Subject: Oyster Creek Nuclear Generating Station
Facility License No. DPR-16
Docket No. 50-219
Response to Request for Additional Information re:
Proposed License Amendment for Spent Fuel Pool Expansion

Enclosure 1

**OCNGS SSE Time Histories at El. 75'-3"
PSD Functions Vs Targets**

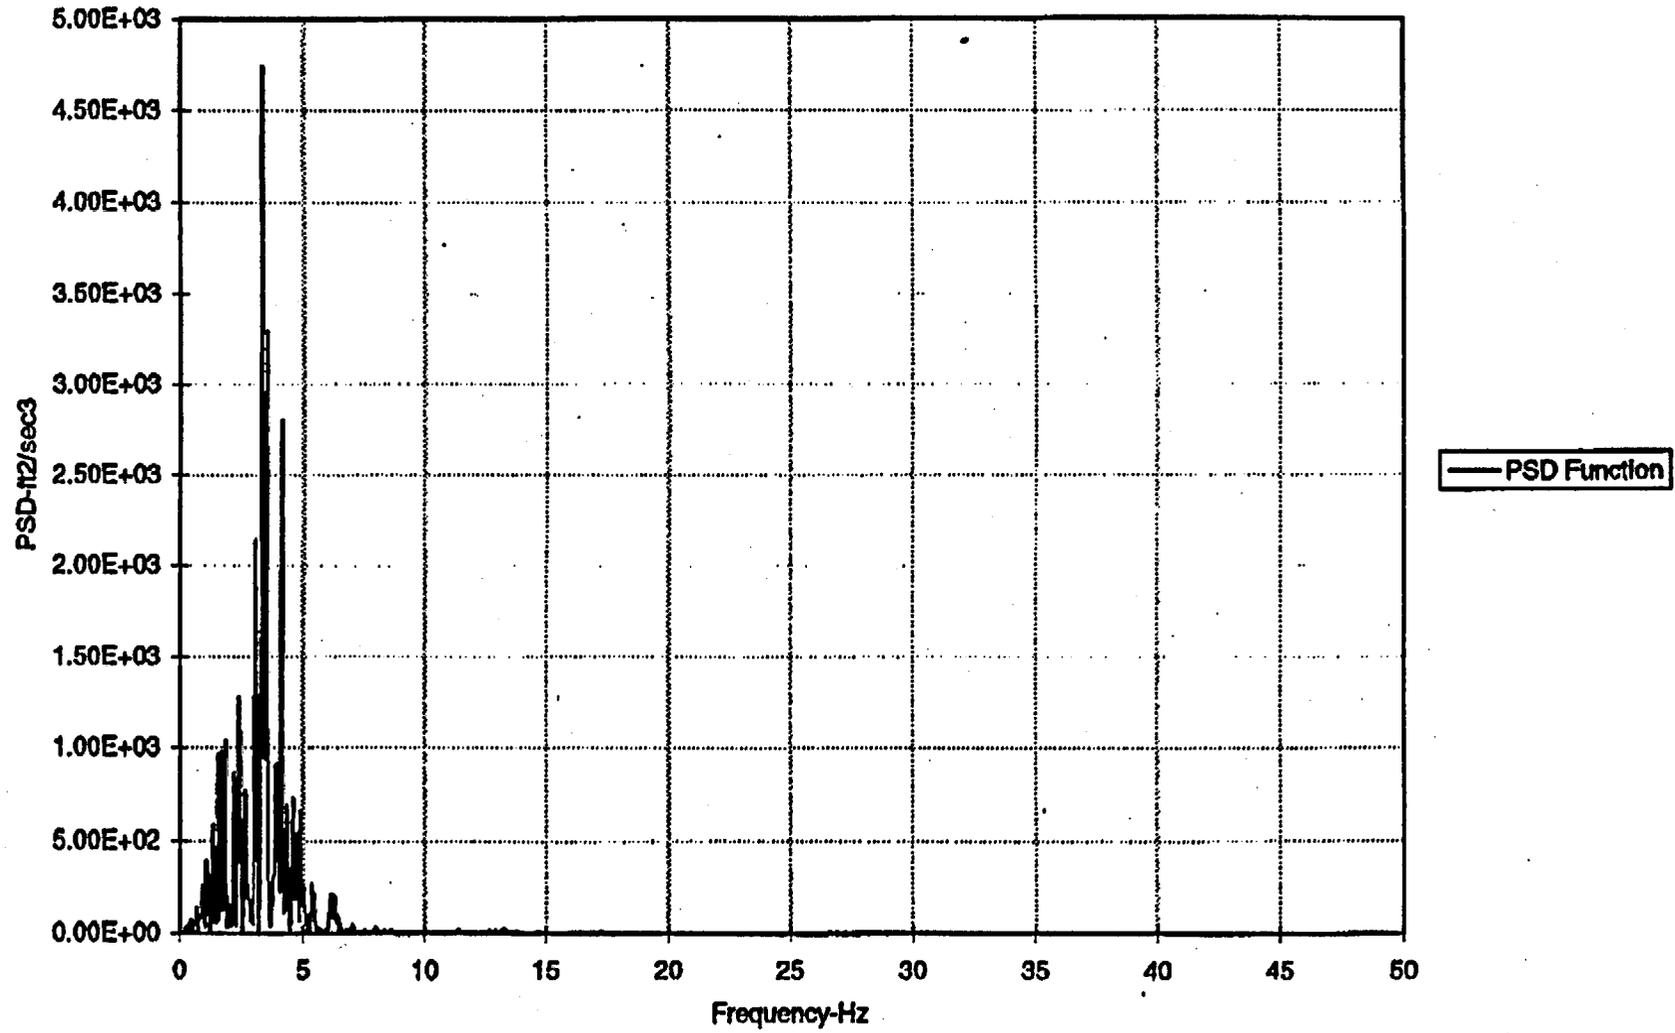
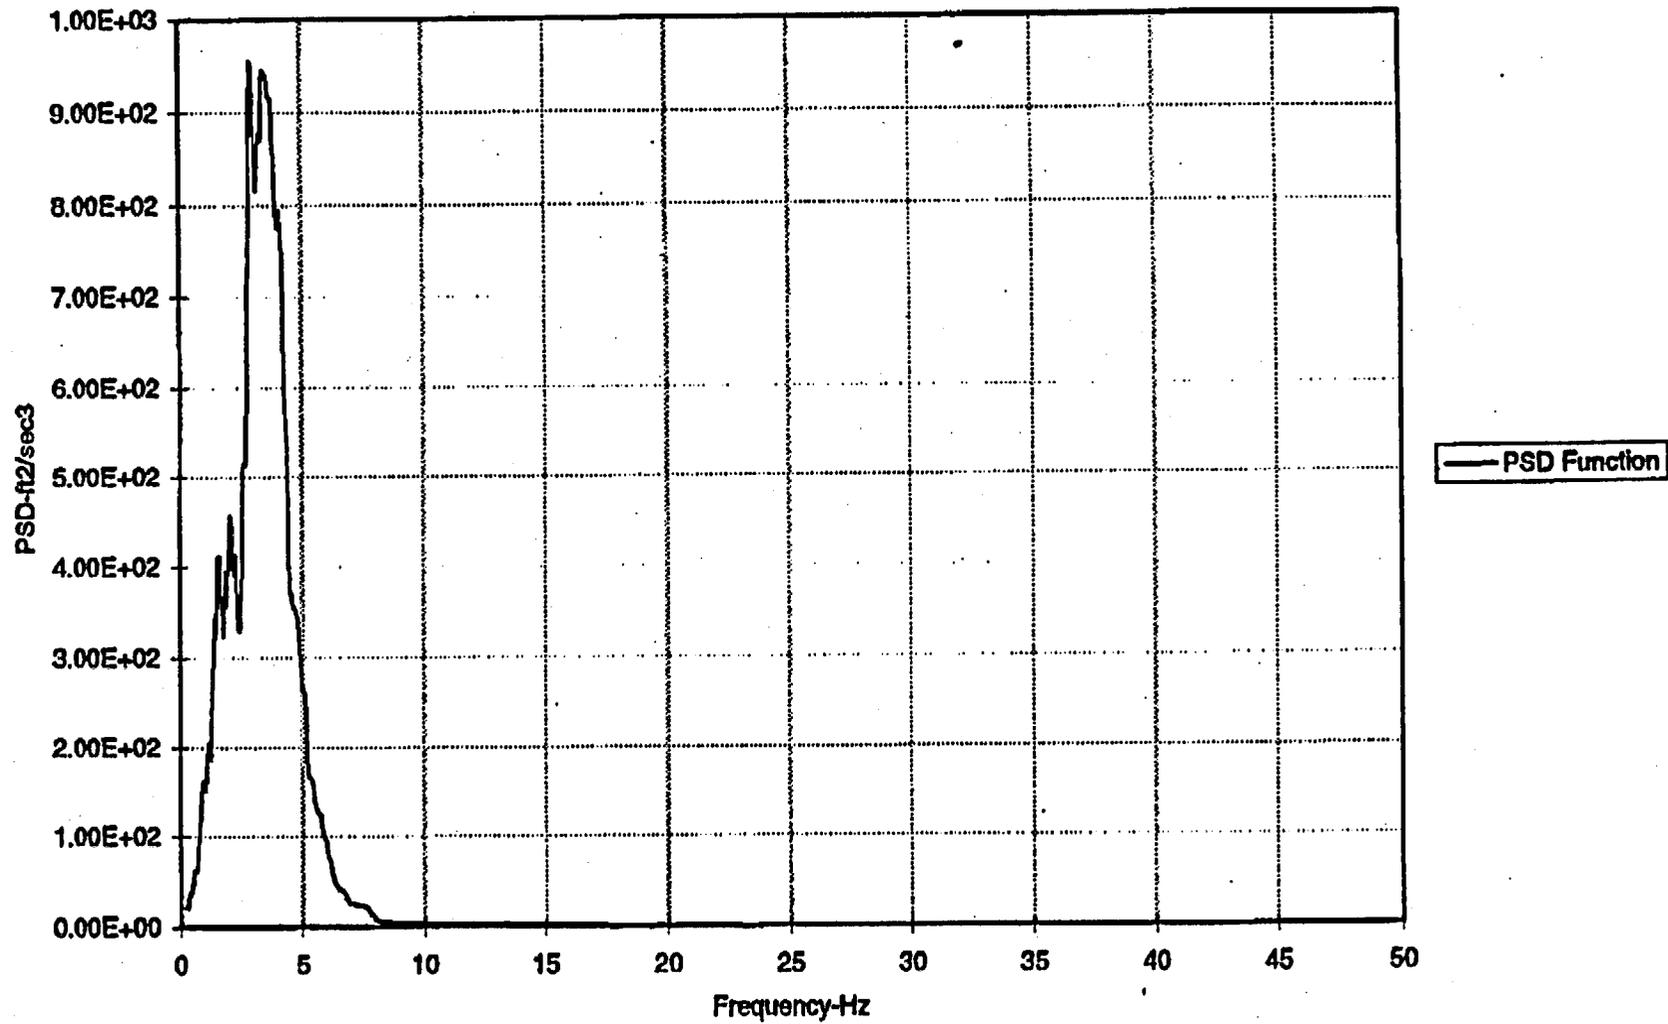
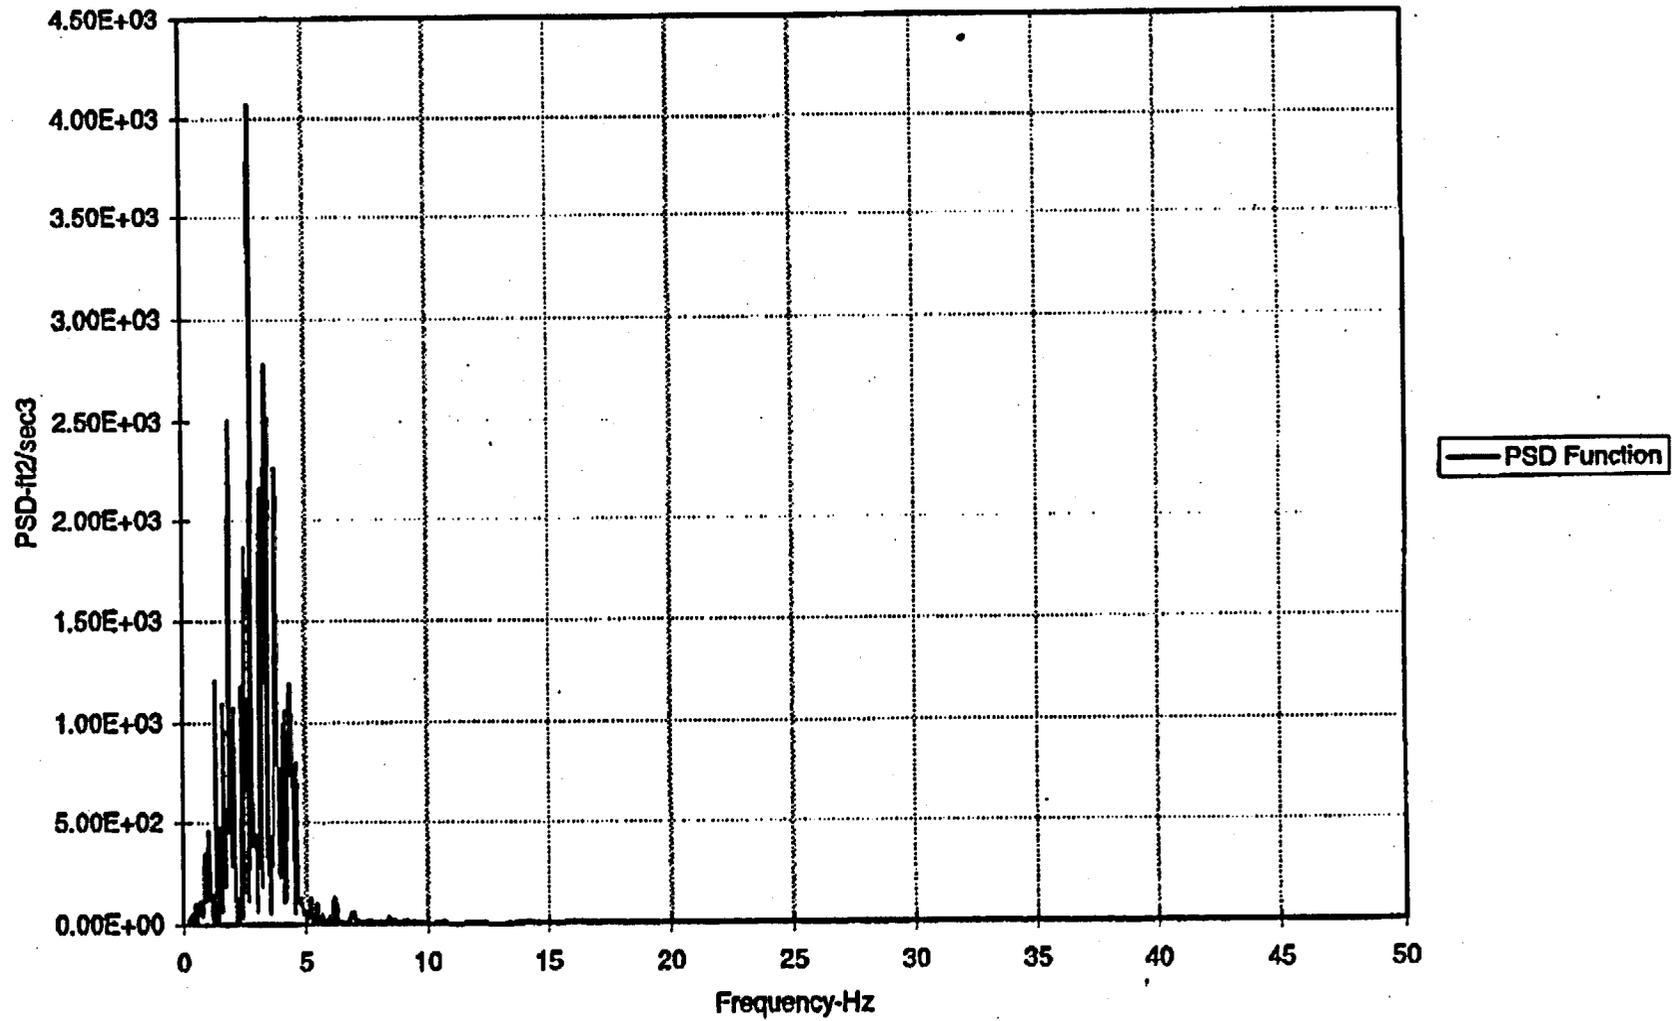
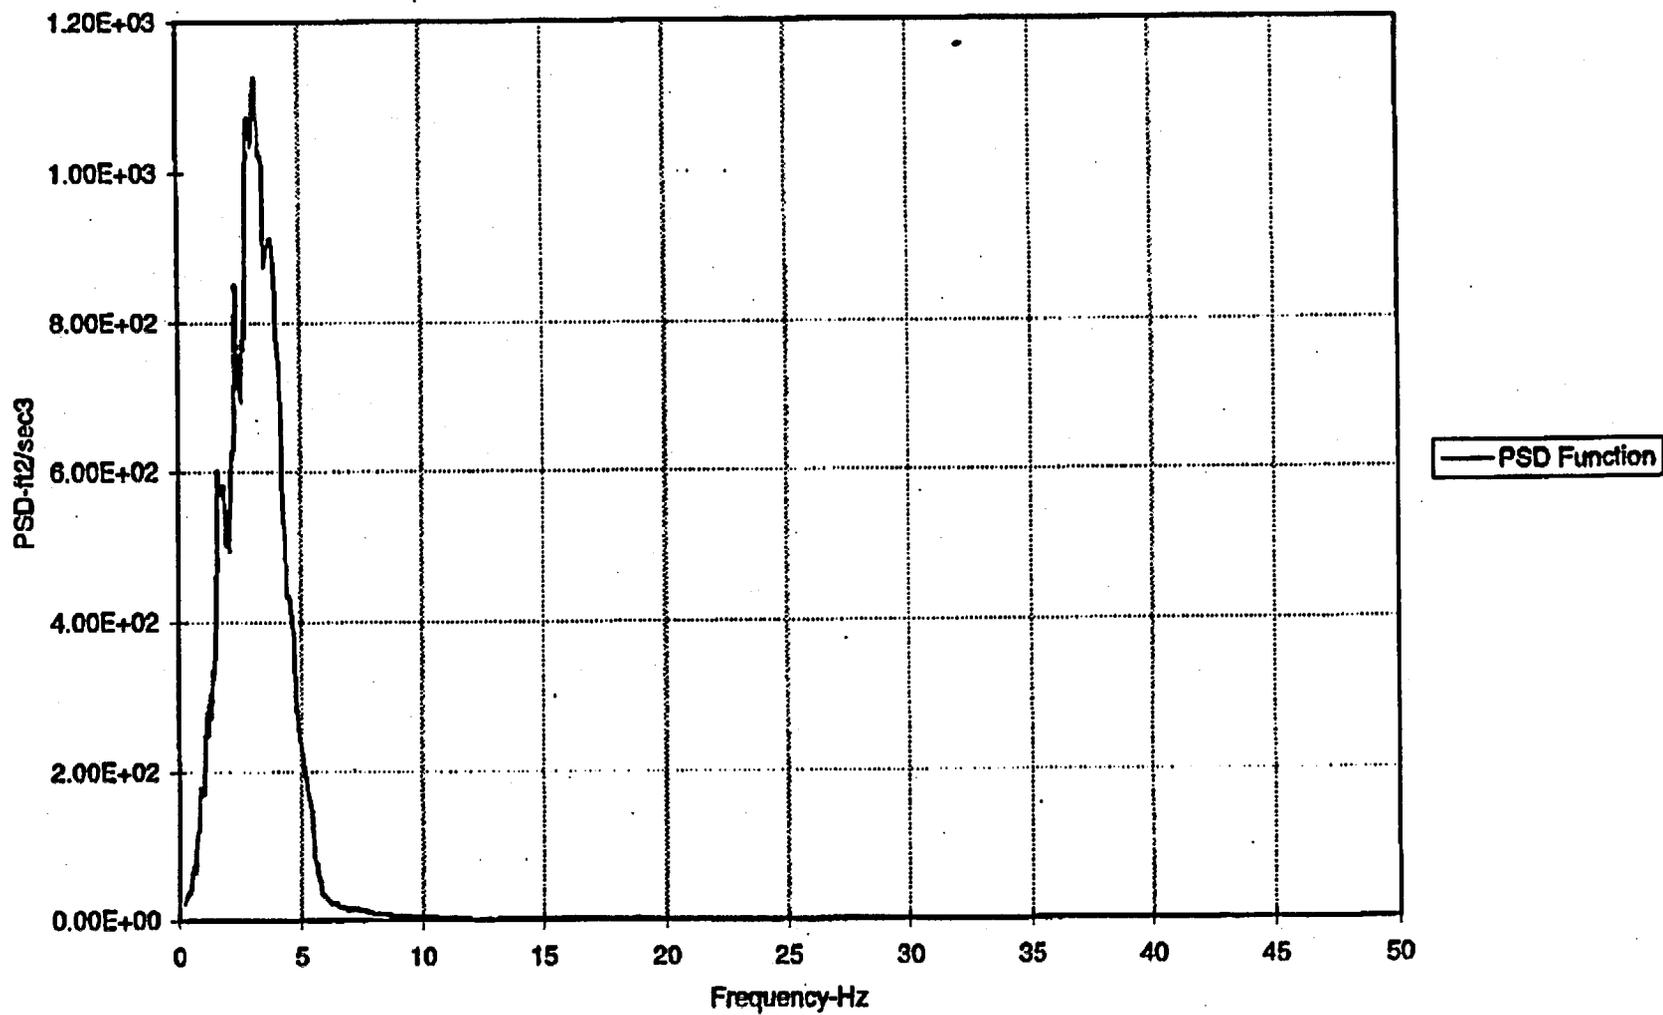
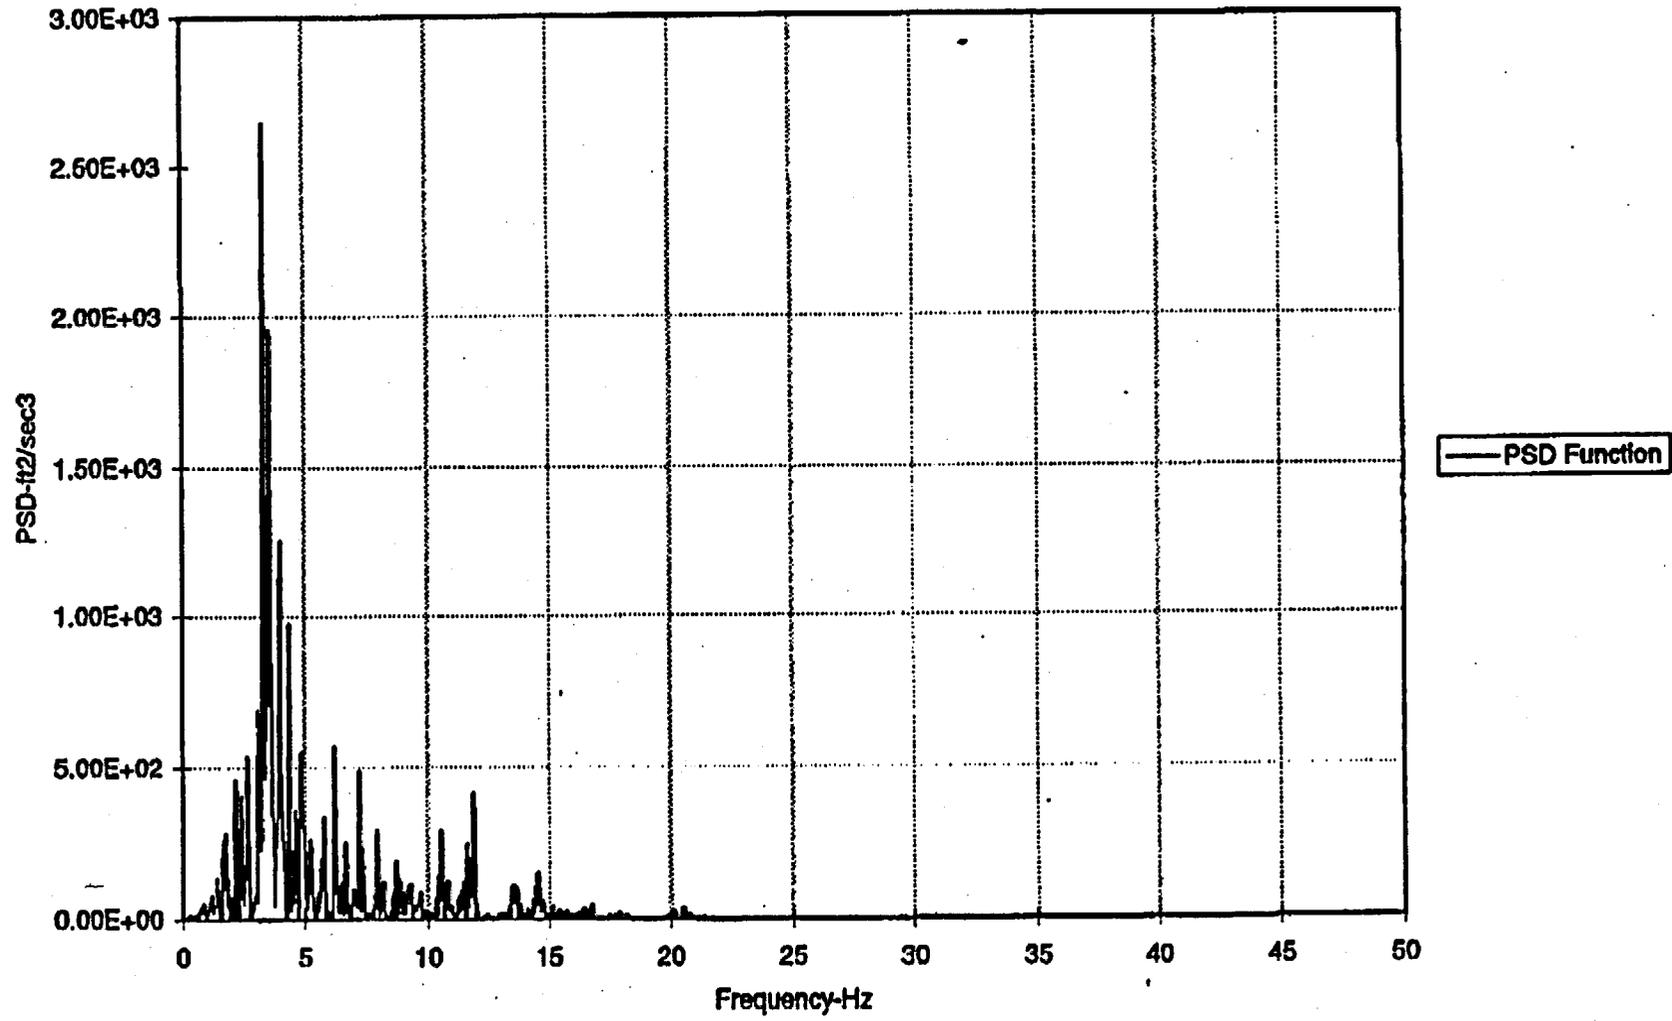
- (c) Provide the physical dimensions of the racks, and the gaps between the racks and the gaps between the racks and the spent fuel pool (SFP) walls.
- (d) Demonstrate that the artificial seismic ground motion time histories used in the analyses satisfy the power spectral density (PSD) requirement of SRP 3.7.1.

The SSE time histories for use in the DYNARACK analyses were also developed by EQE. Attachment 1.4 presents Section 7.0 and Figures 7-1 through 7-6 from the EQE calculation which demonstrate that the time histories derived contain the correct energy distribution with respect to frequency. The OBE time histories, which were generated by Holtec International, also meet the PSD requirements of SRP 3.7.1. Attachment 1.5 contains figures, which provide a comparison of the PSD curves associated with the generated time histories and the PSD curves associated with the design basis response spectra. These figures clearly show that the generated PSD curves envelop the target curves over the entire frequency range.

The "raw" and smooth power spectral density functions are shown in Figures 7-1 to 7-6. There, it is shown that the generated horizontal time histories have the energy concentrated in the 3 to 4 Hz range and practically no energy after 8 to 10 Hz. The vertical time history has a large amount of energy in the 3 to 4 Hz range but also has energy between 4 and 20 Hz. This is consistent with the target floor response spectra and with the characteristics of the dynamic response of the reactor building.
